August 14, 1984

Docket No. 50-336 A04089

Millstone Nuclear Power Station, Unit No. 2 Additional Information for Generic Letter 82-28

REQUEST FOR ADDITIONAL INFORMATION

Refer to Figure 4 (Attached)

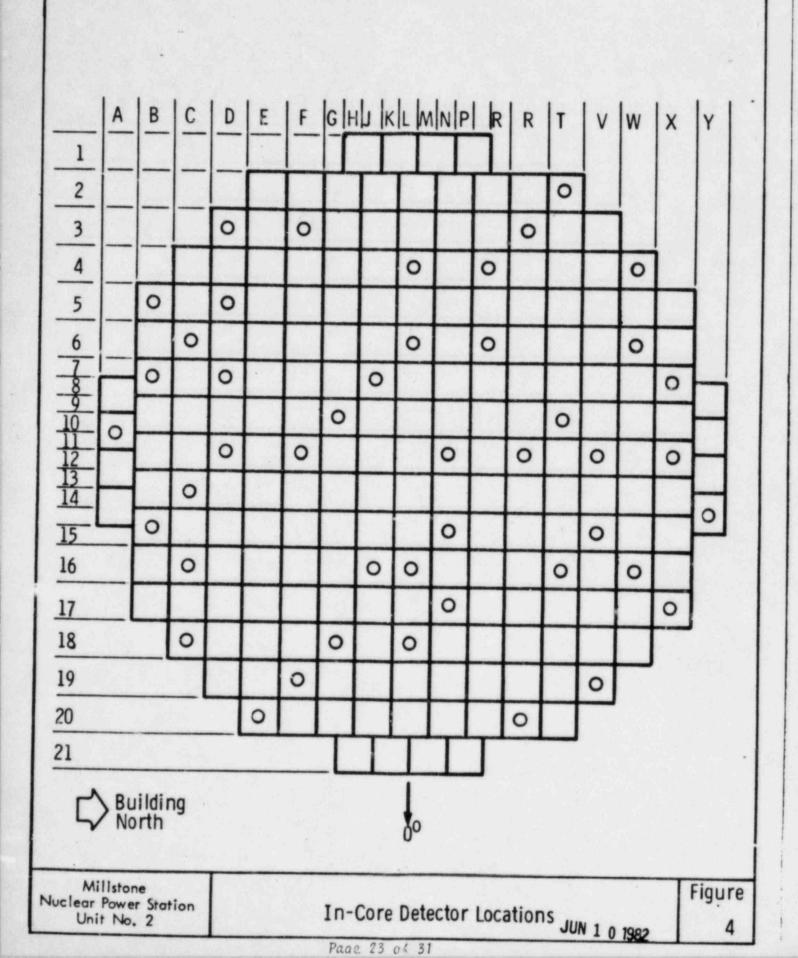
1. Provide diagram of core exit thermocouple locations or reference the generic description if appropriate.
